Summary of Testimony

- ◆ Small land farms pose low risk
- ◆ Flexibility should be afforded operators who utilize site specific data
- ◆ Regulations should be internally consistent, reasonably protective, and implementable

NMOCC HEARING
Landfarm Cell Types

“OCD Proposed Monitoring is Excessive”

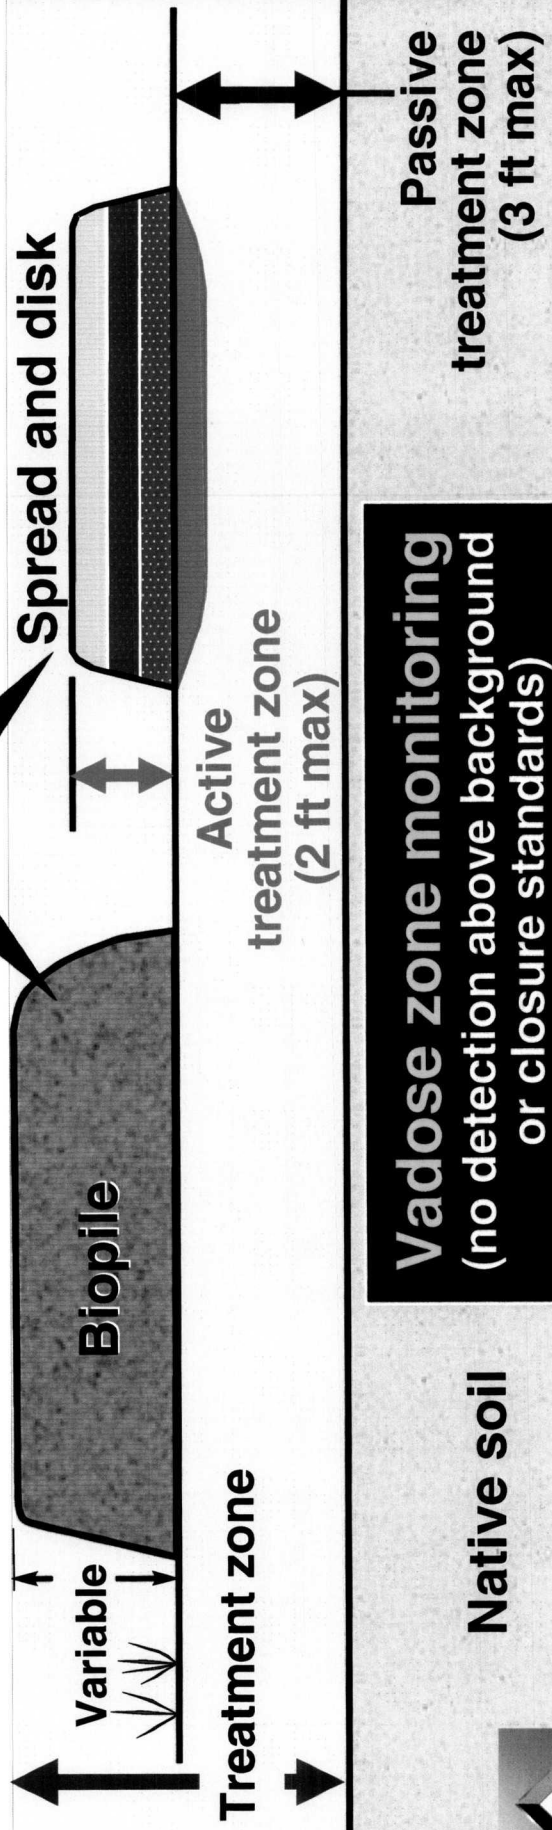
Sample, analyze,
certify waste
CI < 1,000 mg/kg

Semi annual monitor treatment zone
CI < 1,000 mg/kg

Vadose zone monitoring
(no detection above background
or closure standards)

- ◆ Requiring treatment zone monitoring is excessive, with source and vadose zone monitoring in place.
- ◆ Treatment zone monitoring is appropriate if using the bioremediation endpoint approach to closure.
